GENERAL INFORMATION

This section covers the various Pentium® OverDrive® processors.

Summary Table of Changes

Top Markings

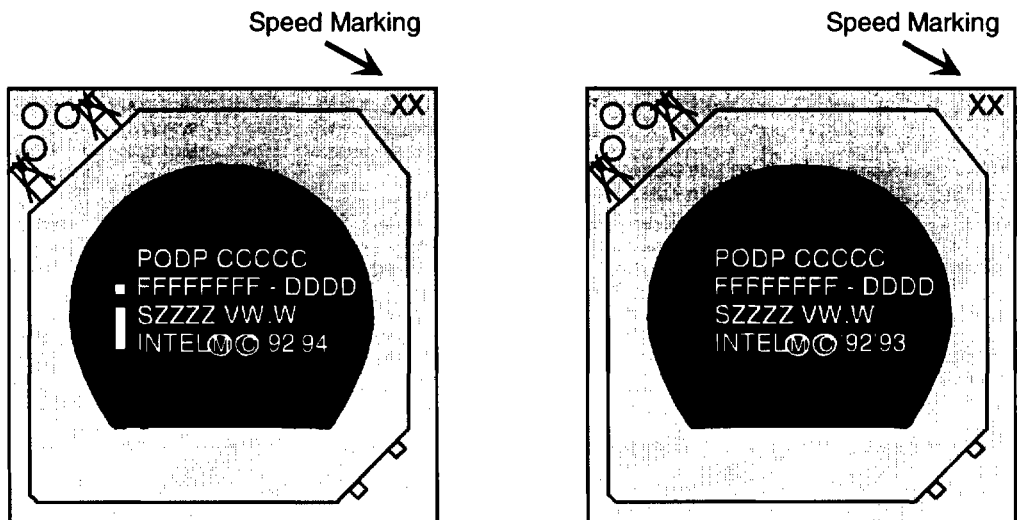
The Pentium OverDrive processor can be identified by the number on the base of the heat sink, under the integrated fan. To remove the fan, squeeze the retaining clips in the upper left corner of the chip and lift up. The figure below shows the laser mark found on the heatsink base of the processor. A marking is also used to indicate the speed of the part and is located in the upper right of the package.
